Minnehaha Creek Watershed District -Permit
Application Supporting Documentation

Orono Interceptor 7113 Improvements

RE: Orono Interceptor 7113 Improvements
Minnehaha Creek Watershed District
Permit Application No. 25-583
MCES Project 802837
SEH Project MCES0 179552

This revised document includes updated information and revisions to address MCWD's comments specific to Erosion Control, Floodplain Alteration, Waterbody Crossings and Structures, and Wetland Protection Rules.

Figure 17 – Temporary Fill Below OHWL

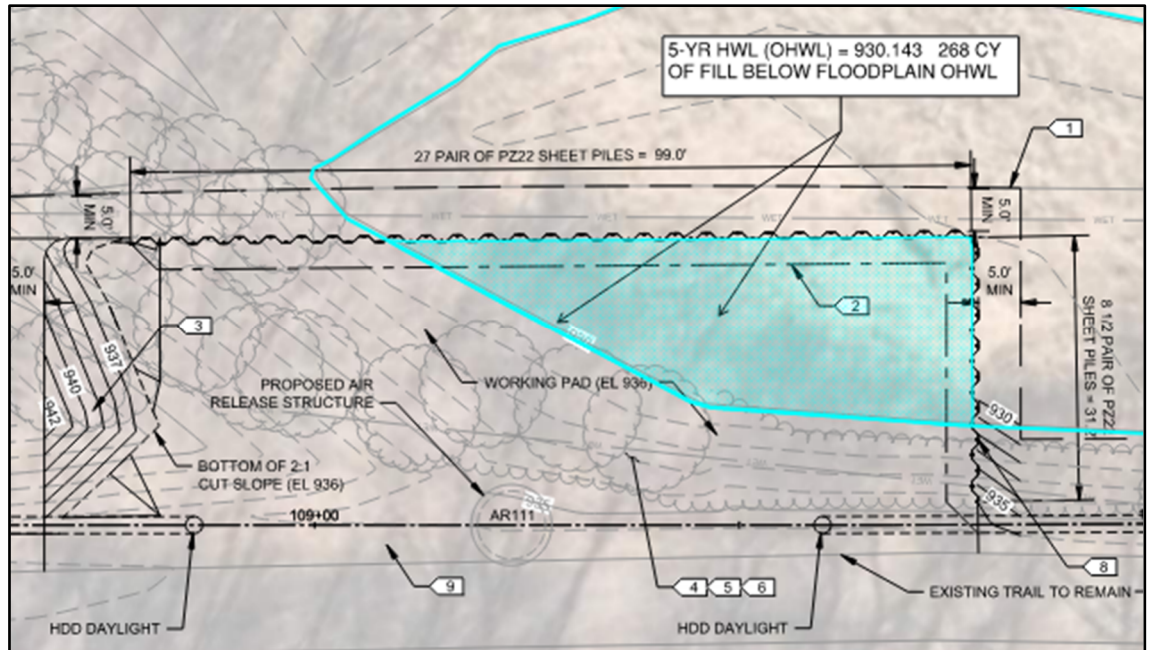
As requested by MCWD, Figures 17 and 18 show the proposed location of the temporary platform relative to the 5-year HWL (OHWL) and 100-year HWL contours and proposed temporary structure.

Figure 22 – Lilac Lane 2025 Wetlands Overview

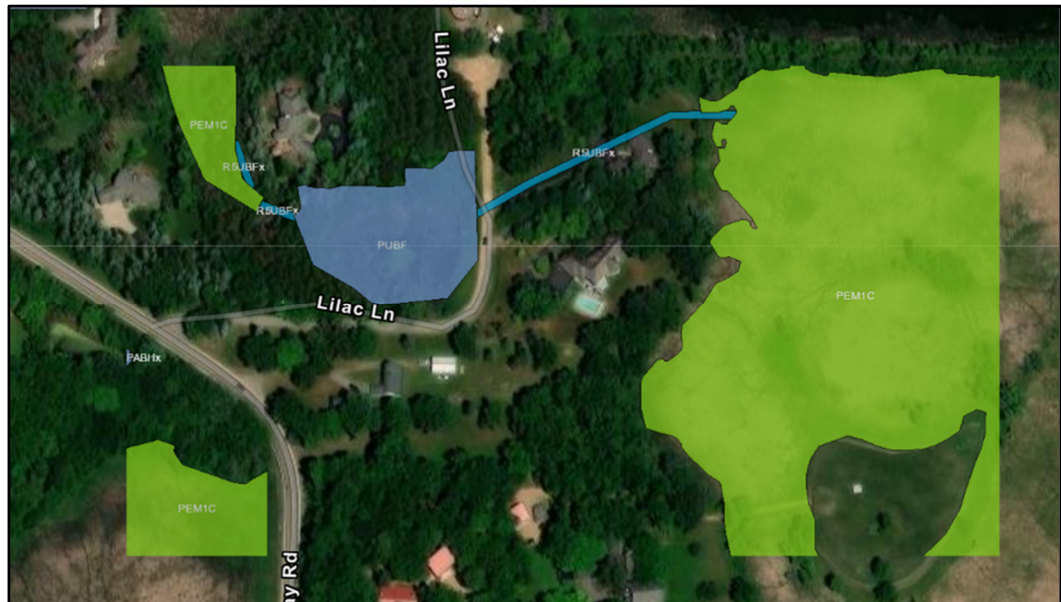
After initial review and additional discussions, MCWD states: *“modeling will be required to show no increase in upstream or downstream flood stages for a 100-year event. This is due to the presence of a watercourse and the scope of work being conducted (culvert replacement, not in-kind), as well as MCWD’s Waterbody Crossings and Structures Rule, Section 3b, which states that “a project in a watercourse may not increase upstream or downstream flood stage.”*

1. No Action- Maintaining the existing culvert is not an acceptable solution given poor condition of the existing culvert and the immediate need for improvements.
2. Replacing the existing CMP culvert with a new RCP is not a feasible solution given that the installation of RCP culvert would significantly increase the hydraulic capacity of the culvert and consequently would have an impact on the flood stage of the watercourse.
3. The proposed design represents the minimum impact solution, considering the interceptor improvements project would be the best time to replace the existing culvert to improve conditions and extend the service life of the system. Conducting all rehabilitation work during one construction project will minimize impacts to the area. A Construction SWPPP will be implemented during construction operations to protect water quality.

Figure 27 – 48” CMP Culvert Proposed Modification

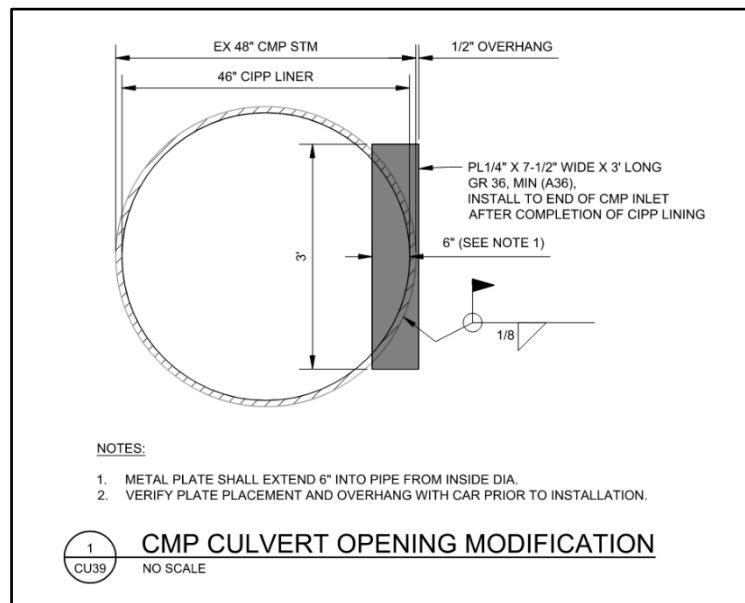
Per discussions with Hennepin County, and based on their maintenance and operations experience, the metal plate installed on the side of the pipe would provide reliable flow control and remain operational even if sediment accumulates overtime at the bottom of the pipe, see Figure 27 and plan sheet CU39.

The XPSWMM model was updated to include the metal plate as requested by MCWD, results indicate the installation of 1-inch-thick liner and metal plate as shown in Figure 27 would result in

Figure 28 – Dakota Trail Area Culver 3 Location

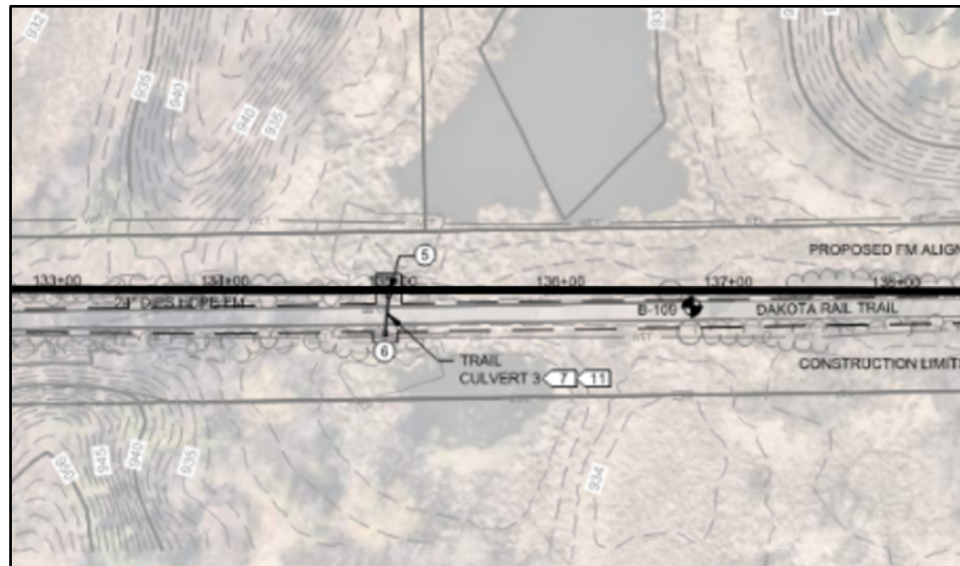
The MCWD states: “ A watercourse is present at the Dakota Trail Culvert 3 location, as seen on MCWD’s Stream Order layer. In this case, the wetland in the area is acting as part of the mapped watercourse. Due to the presence of a watercourse in the area and the scope of work being conducted (culvert replacement, not in-kind), modeling will be required to demonstrate that there will be no increase in upstream or downstream flood stages. See Figure 30.
